May 23, 2000

RE: Review of Wetlands Impacts Resulting from Construction of Temporary Interchange at SR509 and S. 176th Street.

Figure 1. The wetland boundary delineation overlaid on the plan drawing TE-2 of temporary erosion and sediment control plan.

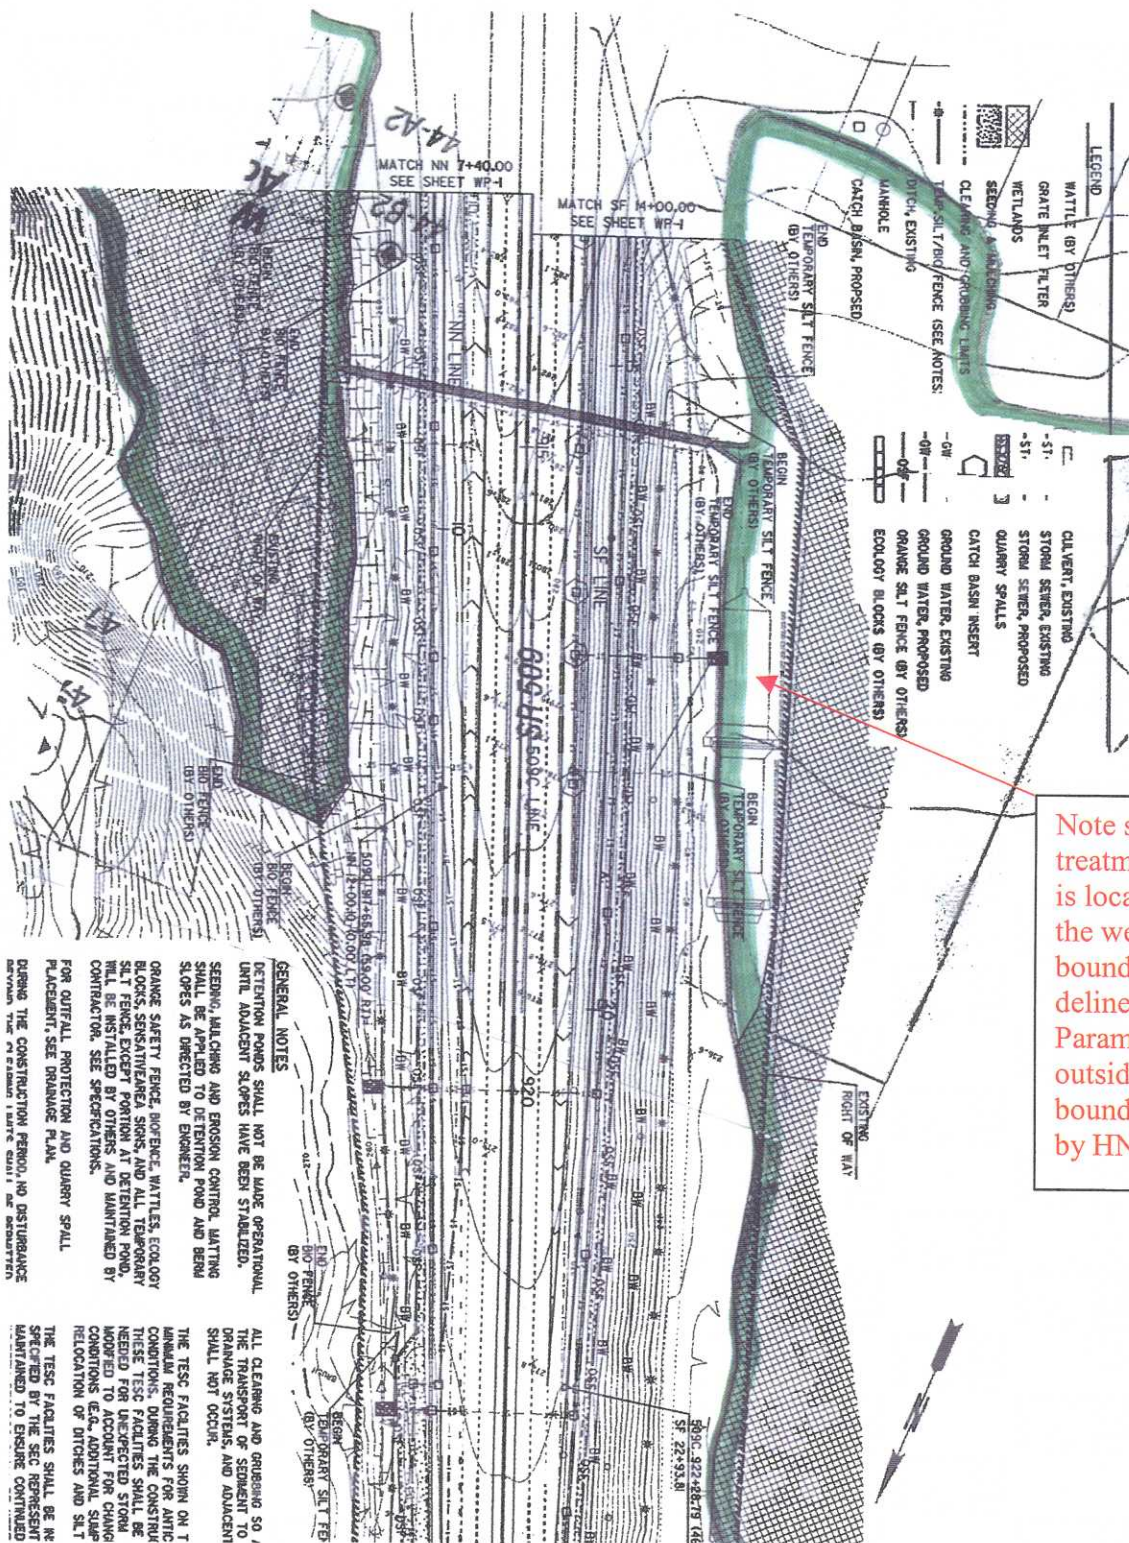
Figure 1 shows the wetland boundary delineation (attached to the May 3rd Parametrix Memorandum) overlaid on the plan drawing TE-2 of temporary erosion and sediment controls. The figure shows that the stormwater facility is actually located in the wetland and the wetland boundary is located on the order of 50 feet closer to the construction zone than discussed in the reporting. Figure 1 also shows contours, which show that the wetland begins at the toe of the fill prism for SR509.

The proximity of the wetland to the construction zone in conjunction with the steep slope on which construction will occur means there will be direct impacts to Wetland 43 from sedimentary discharges due to rainfall events in conjunction with construction activities. Although temporary erosion control measures have been specified for the project, they will not prevent sedimentary discharges to Wetland 43 given the project site conditions.

In addition, it is not accepted professional practice to site stormwater facilities in a wetland due to the lack of adequate treatment that results under those conditions. It is

unclear from the reporting how the stormwater facility will be used. Since it is within the wetland boundaries, alterations to the wetland for purposes of stormwater management should be regulated.

Note stormwater treatment structure is located within the wetland boundary delineated by Parametrix and outside the boundary shown by HNTB

Figure 3. Range of distances required to prevent direct loss of wetland functions.¹

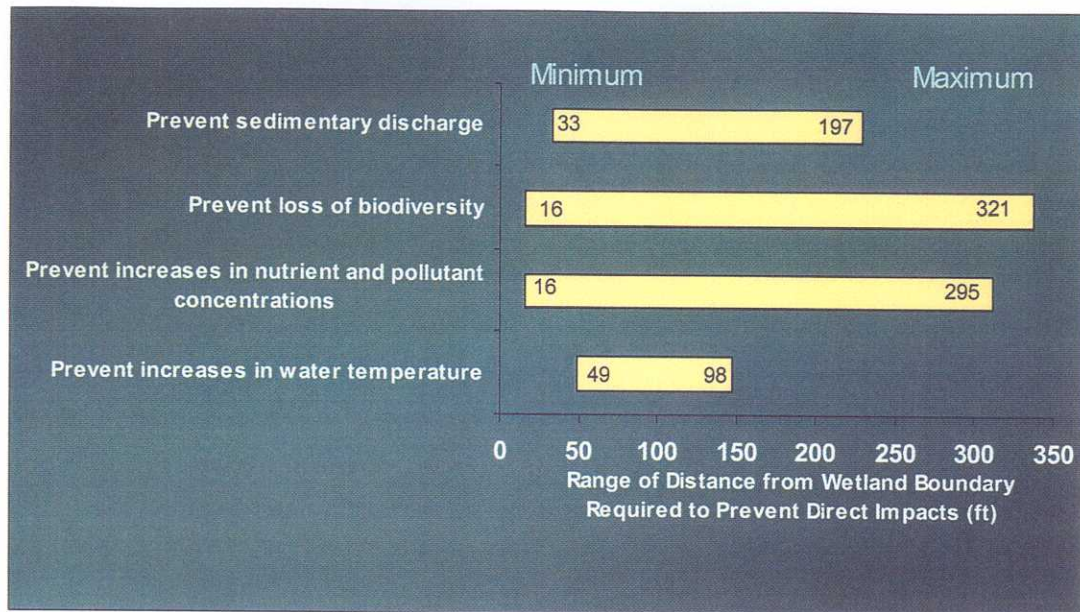
Figure 3 shows results of a scientific review of several studies addressing what area is needed to protect different wetland functions. The first bar shows that discharge of sediment to a wetland requires a distance from the source of a minimum of 33 feet up to a maximum effective distance of 197 feet. Wetlands requiring only 33 feet between the sources of sediment for adequate protection are low quality wetlands with heavily vegetated buffers in flat or nearly flat terrain. Wetlands requiring a distance of 197 feet would be high quality wetlands in steep terrain with poorly vegetated land cover. Wetland 43 is a moderate to high quality wetland (Category 2) in steep terrain, at the base of a highway with a poorly vegetated upland (significant percentage of bare ground between plants). Based on the results of numerous scientific studies, sedimentary discharges to the wetland are probable, given the close proximity of the sediment source (as little as 40 feet in many areas) and the steepness of the upland construction zone.
